**GLOBAL NUCLEAR FUELS – AMERICAS**  
**REQUEST FOR SUPPLEMENTAL INFORMATION**

1. The report “Seismic, Wind, Rain, and Snow Evaluation of the Global Nuclear Fuels - America FMO and FMOX Buildings” by Atkins Energy states the seismic response modification coefficient,  $R$ , is taken as 4.5 and the lateral force resisting system is assumed to be a steel intermediate moment frame in both directions for both the FMO/FMOX structure. The report states, “The calculated displacements and story drifts indicate that the building connections have seismic capacity and are indicative of intermediate seismic capacity joints and are reflective of the intermediate moment frame building classification.” This statement fails to adequately justify the basis to use a seismic response modification coefficient of 4.5 and a categorization of the lateral force resisting system in both directions as an Intermediate Moment Frame.

**Figure 3-1 Inelastic Behavior of Frames with Hinges in Beam Span**

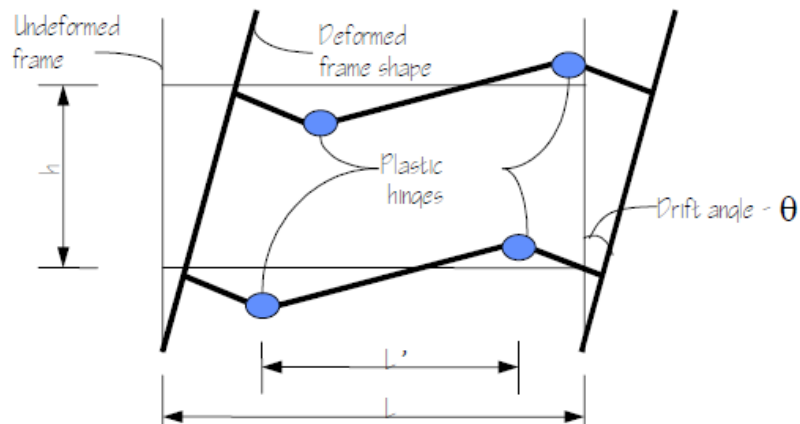
As discussed in Figure 3-1 of FEMA 350<sup>1</sup> provided below, the conditions required for ensuring adequate ductile behavior of frame structures rely on the development of sufficient number of plastic hinges forming in the beams and providing significant energy dissipation. Also, as discussed in the figure, development of plastic hinges in the column is undesirable as this provides relatively little energy dissipation. Although the staff understand that there is a certain level of ductility in the FMO/FMOX structure, the existing report provides little evidence to support the use of a response modification factor consistent with an Intermediate Moment Frame structure.

- a) Provide justification for the assumption that the east-west lateral force resisting frame consisting of columns, roof trusses, and bracing and the north-south lateral force resisting frame consisting of columns and roof trusses meet the member and connection requirements of an Intermediate Moment Frame provided in Section E2 of AISC 341-10 *Seismic Provisions for Structural Steel Buildings*. The seismic requirements of ASCE 7 require steel structures to meet the requirements of AISC 341 in order to classify the structure as an Intermediate Moment Frame. The
